To: Todd Sexauer
 Senior Environmental Planner
 Santa Clara Valley Water District
 5750 Almaden Expressway
 San Jose, CA 95118

As a Santa Clara valley resident and native Californian I understand the economic value of new water capture systems and our long-term water supply challenges, but the proposed Pacheco Reservoir Expansion Project (Pacheco Dam project) will likely have many profound and significant negative environmental impacts, cause unconscionable damage to a region rich in Native American artifacts and human remains, and is simply unjustifiably expensive for the amount of water it could provide. In this letter I will submit the evidence to support those concerns.

One major, multi-faceted problem with the Draft Environmental Impact Report (DEIR) for this project is that it either minimizes or outright fails to disclose all the environmental impacts of the project. It acknowledges, for example, that some plant and animal species within the project area are “sensitive”, but fails to point out that the State of California recognizes a *rank* of sensitivity levels. [Table 3.5-1 from the 2021 DEIR is shown below.]

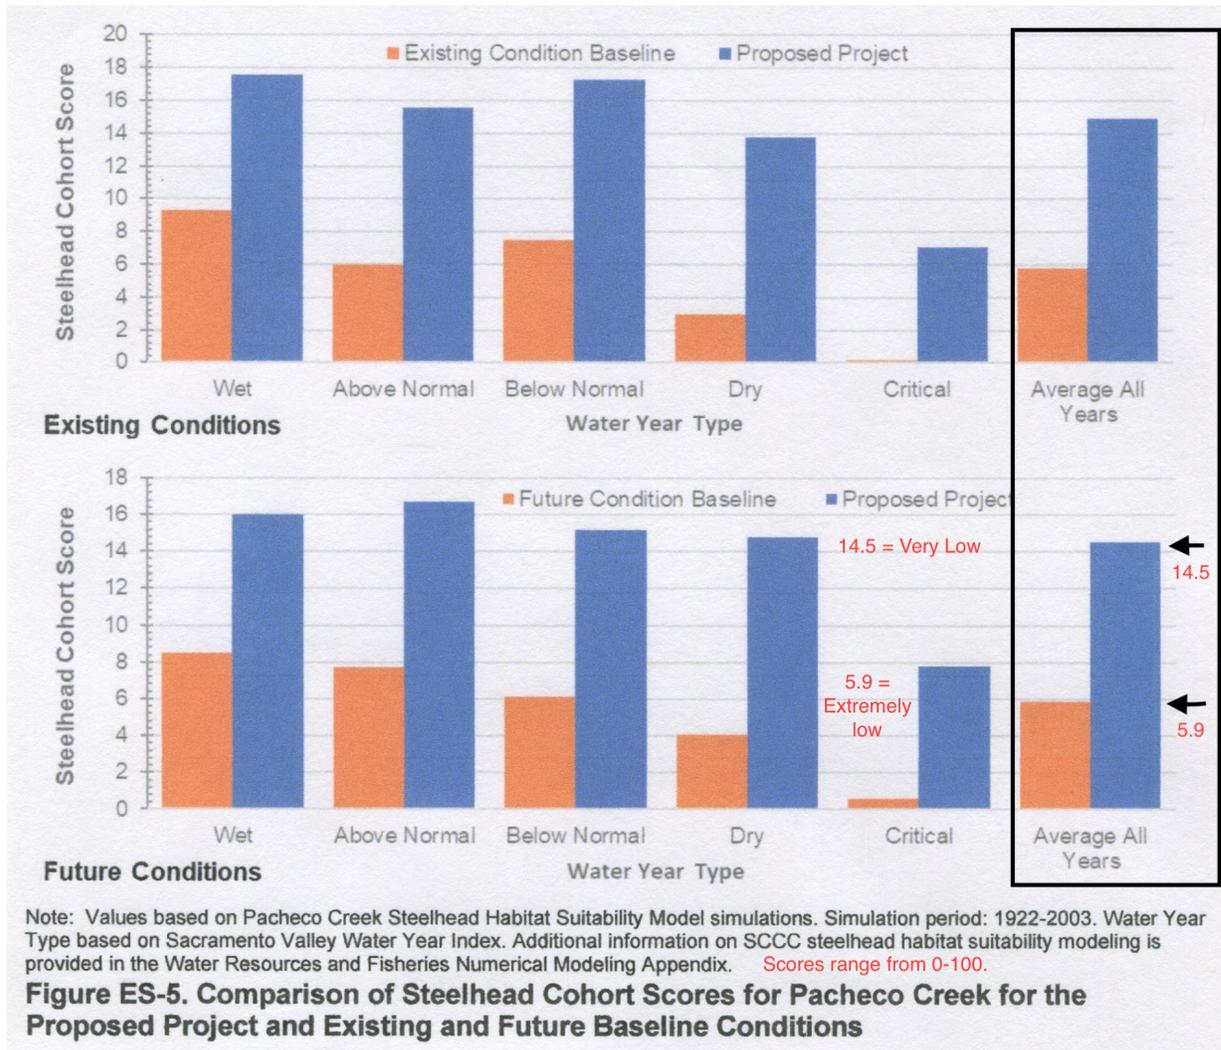
As pointed out by Dr. Jeffrey Michaels in his Nov. 29, 2021 analysis of the Pacheco Dam project (13), the Feasibility Documentation provides no evidence that habitat improvements, per se, will create a steelhead population in Pacheco Creek, especially considering the rather **meager increase in habitat suitability** the project proposes to provide. Consider the Figure ES-5 (below) from the DEIR.

Note that for all the many millions of dollars the project proposes to spend on SCCC steelhead stream flow and habitat improvement, by their own DEIR data **the “Steelhead Cohort Score” (which they propose is a measure of habitat suitability) is increased only from 5.9 out of 100 (extremely low habitat**

suitability) to 14.5 out of 100 (a *very low habitat suitability*). As an engineer colleague commented, “This looks like and increase from *terrible* to *merely pathetic*”. Finally, even if the project does provide *marginally* “improved stream flow conditions”, it is **irrelevant unless** the SCCC steelhead re-inhabits the stream *and* shows **increased occupancy, and increased survival and reproduction** of the steelhead population in that stream.

Figure 1. Net Present Value of Claimed Public Benefits from Pacheco Dam as Compared to Estimated Values Following WSIP Guidance

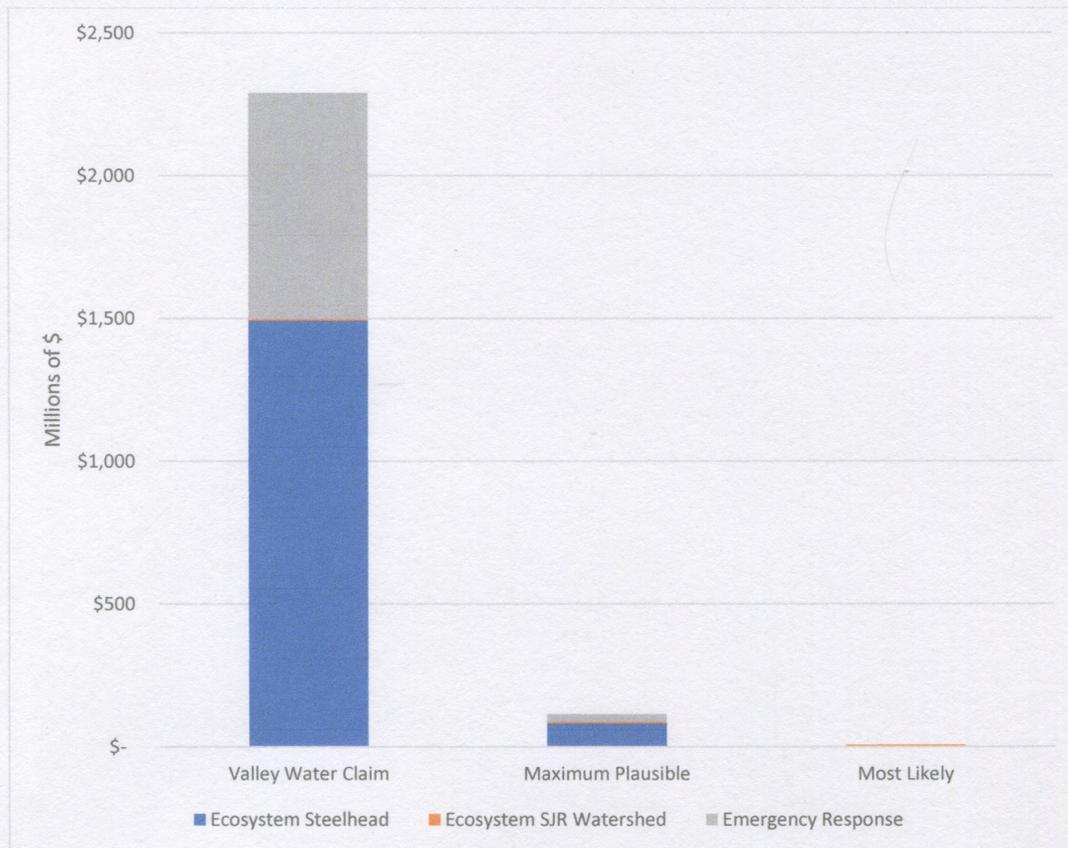
“It is apparent that **an accurate benefit-cost analysis is not even close to supporting the \$2.12 billion cost to Valley Water ratepayers and the State of California, and the public benefits are far too low to justify the nearly \$500 million award Valley Water seeks from the WSIP**. As shown in Figure 1 (below), **Valley Water’s claimed public benefits are more that twenty times the maximum plausible value of public benefits.**”

Dr. Michael presents a very clear cost-accounting to support the graphs in Figure 1 above, very logically debunking the hyperinflated monetary “public benefits” claimed by Valley Water. His analysis of the claimed “public benefits” resulting from changes to SCCS steelhead habit in the project are, for example, compared to other steelhead projects in California and among a group of Western states in the USA. The West Coast Region of the National Marine Fisheries Service (NMFS), for example, also has a recovery plan for SCCC steelhead population located in the watersheds from the Pajaro River south to Arroyo Grande Creek. NMFS estimates the recovery cost for the SCCC steelhead population will be \$560 million borne over the next 80 to 100 years, with the benefits of the myriad projects proposed far outweighing the benefits of the improvement in habitat on Pacheco Creek. Most tellingly, **the benefit estimate Valley Water has placed on the habitat improvement from the Pacheco Dam project is nearly *three times* the estimated cost for the NMSF project that will substantially improve steelhead habitat throughout the *entire range of the species!***
